# THE MEMPHIS DEPOT TENNESSEE

AR File Number 364

**Final Field Sampling Plan Addendum for Operable Unit (OU) 3**

**DATE:** September 25, 1998

Figure 4  
RI Site 59, Building 273  
Constituents Exceeding Risk-Based Criteria  
Defense Distribution Depot Memphis, TN

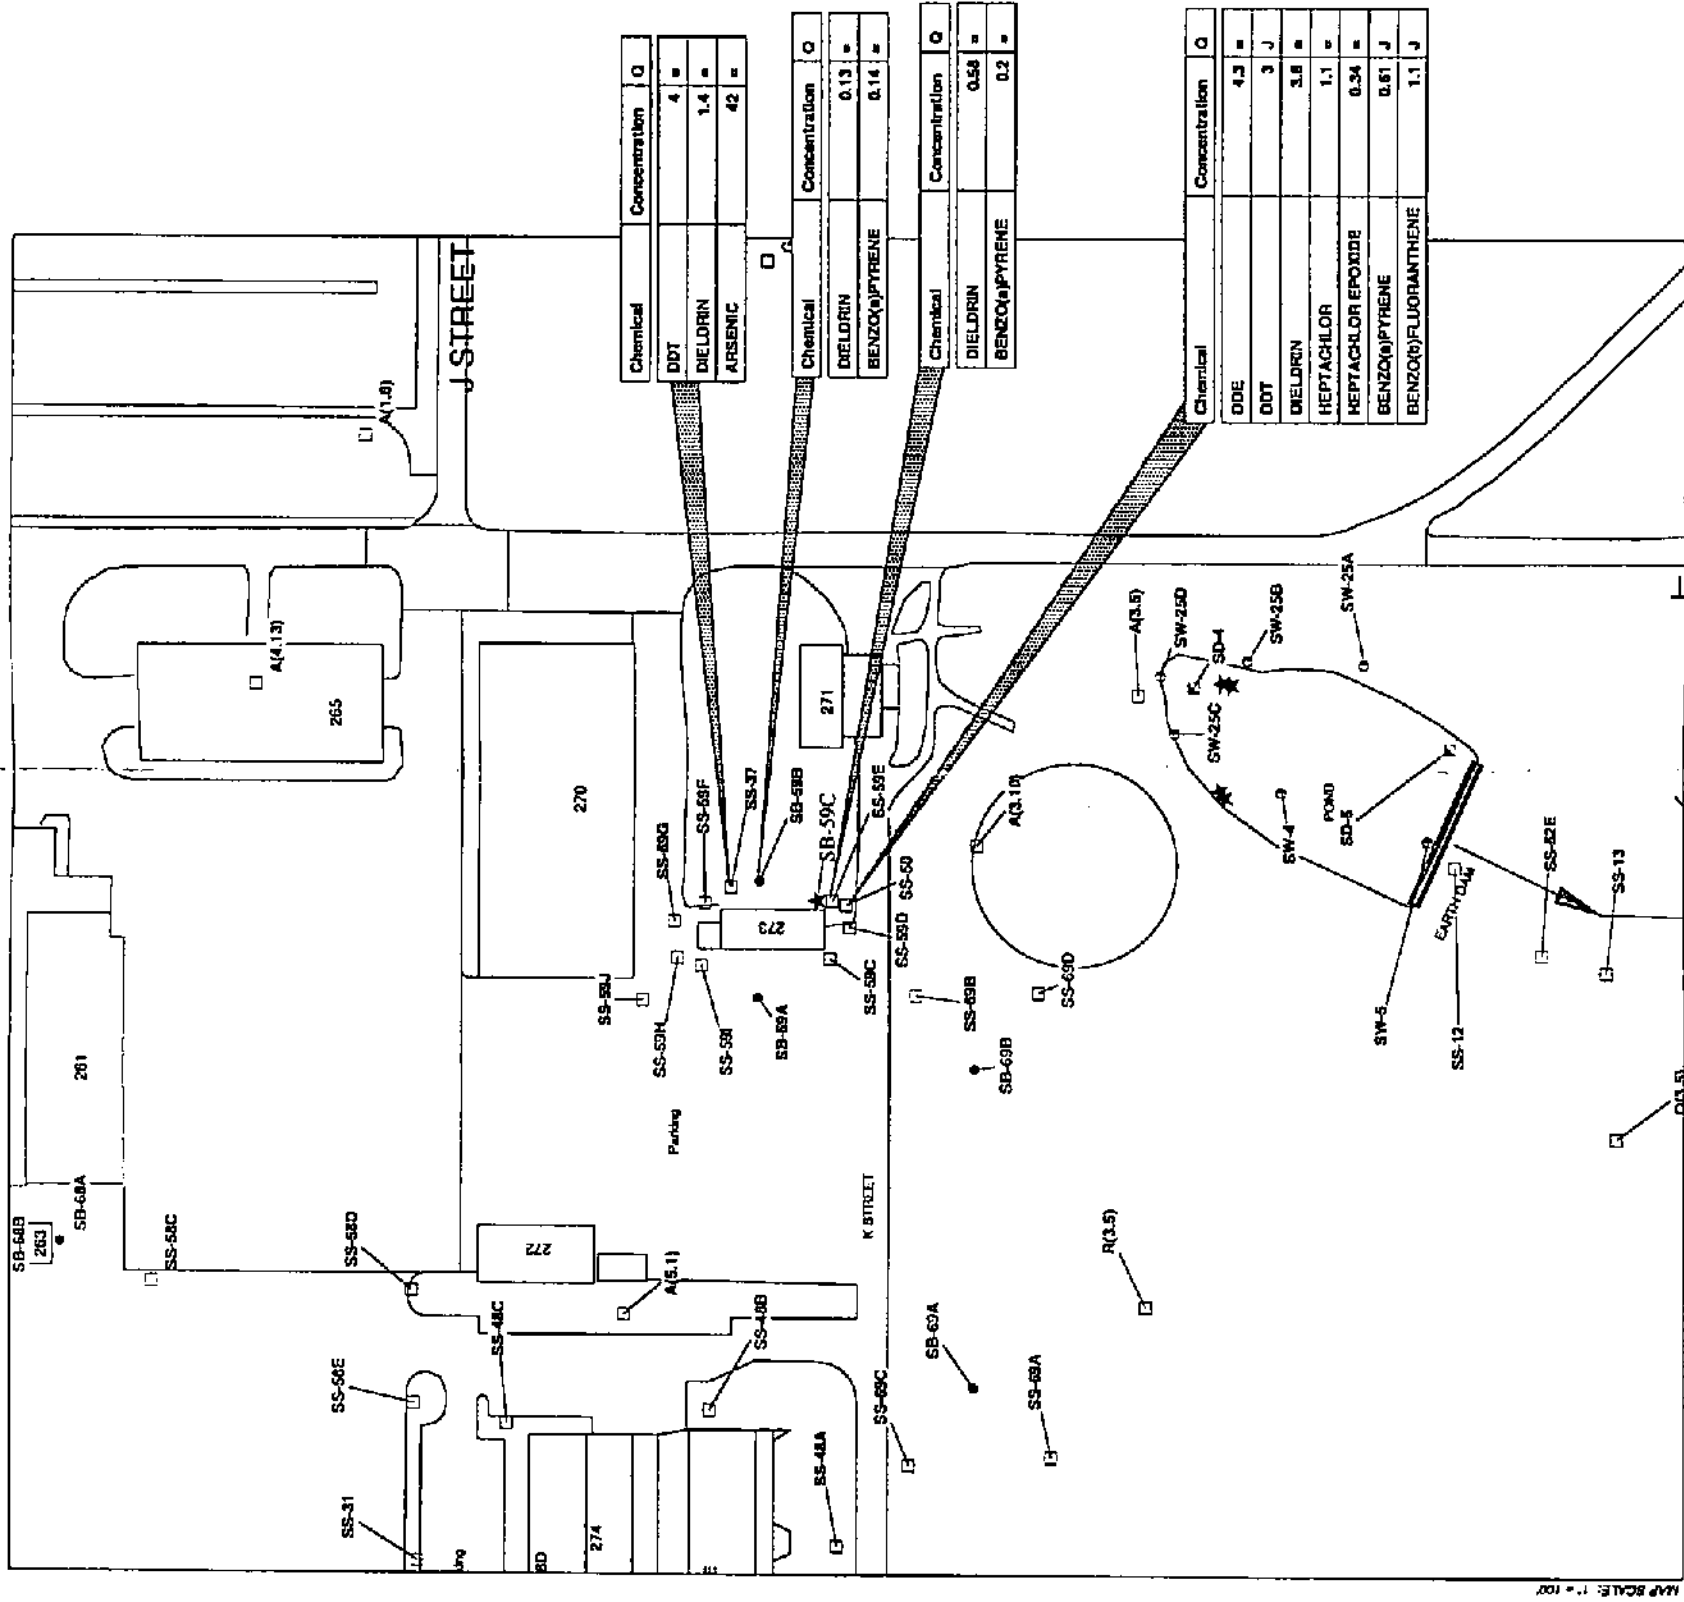
The COPCs at RI Site 59 include polyaromatic hydrocarbons (PAH) compounds, arsenic, DDT, DDE and dieldrin. One additional boring (SB59C) will be taken southwest of Building 273 to characterize the vertical extent of contamination at this location to provide vertical extent data near an area where significant contamination was reported earlier. The sample will be collected at a depth of 10 ft and will be analyzed for TAL/TCL compounds to assess the presence of pesticide carrier compounds and other possibly associated metals (Table 4). See Figure 4 for the new boring location.

**Figure 7**  
**Container Storage Strip**  
**Proposed Sampling Location**  
 Defense Distribution Depot Memphis, TN

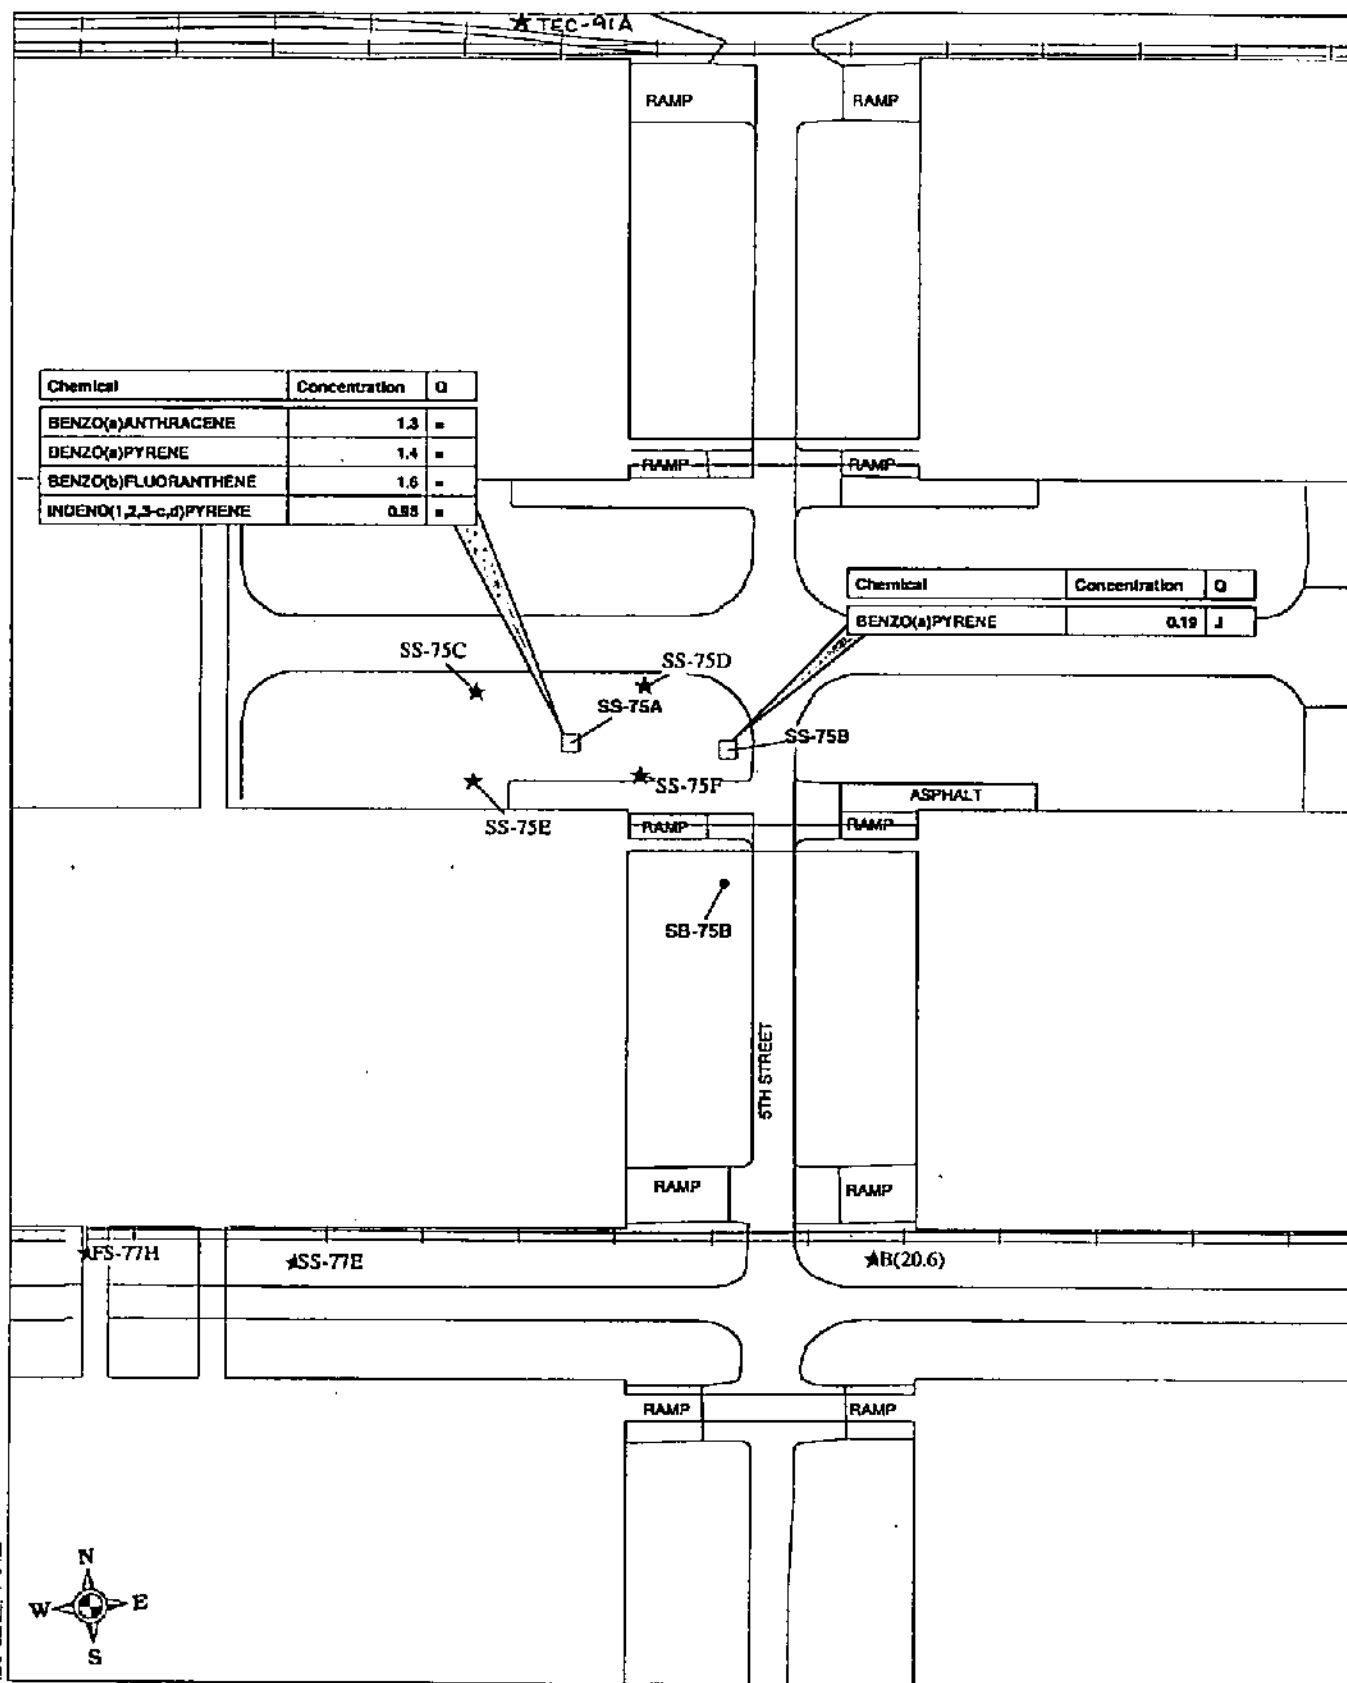
One 10-foot boring (TEC-91A) will be obtained in an area of previous concentration of containers, that is still accessible (ie not covered by a building), as shown in Figure 7. Two soil samples will be taken from the boring – one at the surface and one at a fill interface, if it exists. If not, the second sample will be taken at 3-5 feet. Both samples will be analyzed for TCL/TAL, as shown in Table 8.
